**Summit County Planning Commission (SCPC)**

Thursday, March 28, 2024 - 3:00 p.m.

**Meeting Agenda**

Planning Commission  
 Preliminary Plan  
**Swan Lake**  
 Copley Township

**STANDARD AIRBRIDGE DETAIL**

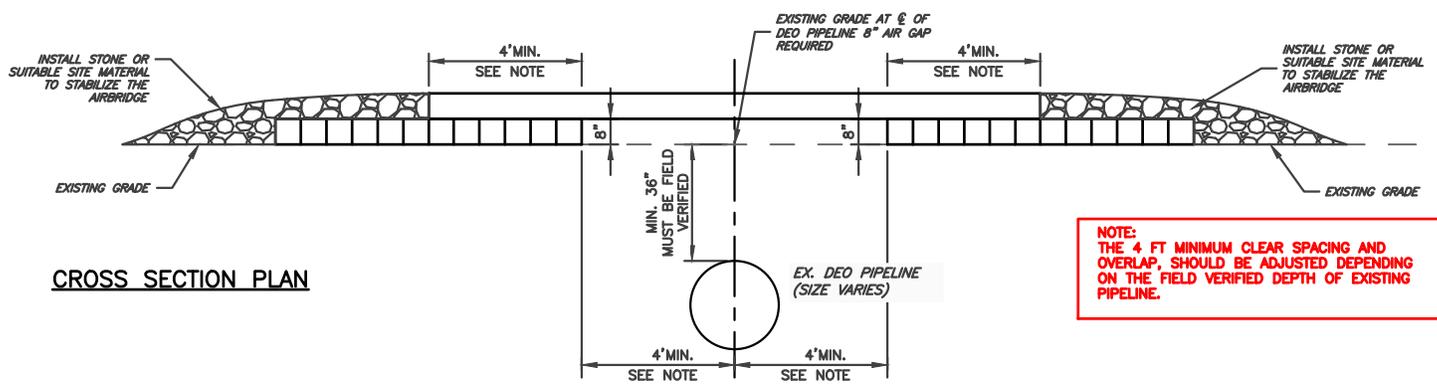
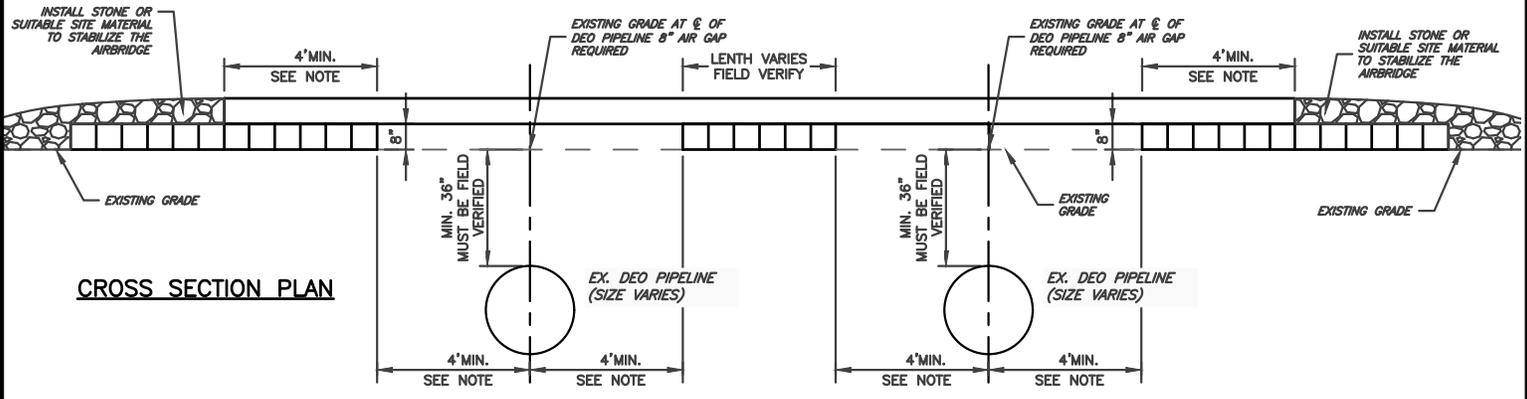
**NOTE:**  
THE 4 FT MINIMUM CLEAR SPACING AND OVERLAP, SHOULD BE ADJUSTED DEPENDING ON THE FIELD VERIFIED DEPTH OF EXISTING PIPELINE.
